**Subject**: Bear Valley Electric Service, Inc. Response to Notice of Violation- NOV\_BVES\_CAC14\_20231024\_0818 (No Written Hearing Requested)

## Notice of Violation: NOV\_BVES\_CAC14\_20231024\_0818

After Trimming on November 17, 2023

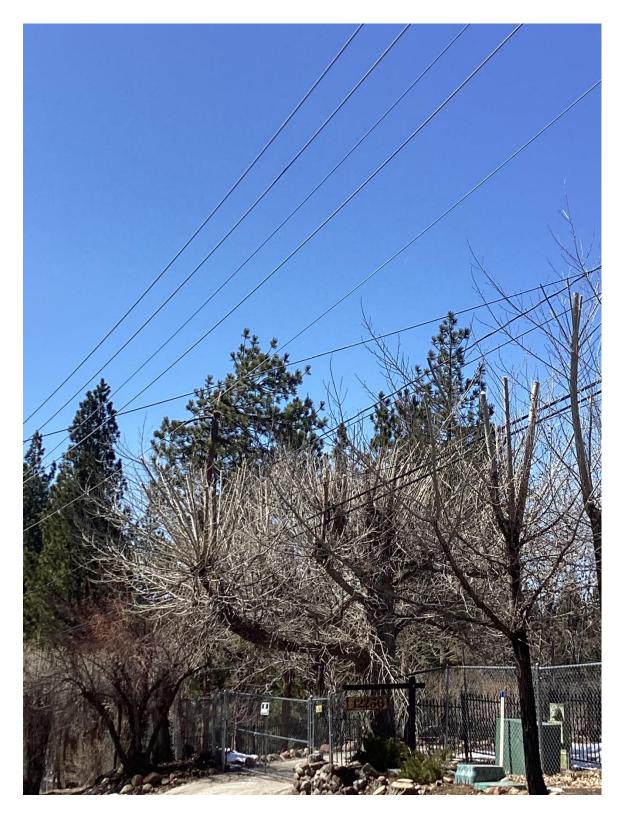
**Finding:** Near pole ID IR3469 at 42128 Switzerland Dr, Big Bear Lake, CA, 92315, USA, 34.2372390327414, -116.883346825071, the inspector observed that vegetation was growing within the 72-inch safe clearance distance under primary covered conductors. The inspector's observation is documented in Violation 1 photographs, which are attachments to this report. Photo numbers Item1IA1Img1 and Item1IA1Img2 depict a tulip tree growing approximately six feet under primary covered conductors.

**Response:** This violation located near pole number 1300BV located at (Lat/Long: 34.2372390327414, -116.883346825071). was corrected on 11/17/2023 as part of BVES's routine vegetation management program. The tree was trimmed to approximately 12 feet from the primary conductors. Additionally, when this notice was sent to BVES on March 15, 2024, the lines were re-inspected for any additional growth. No additional action was needed. See photos below.
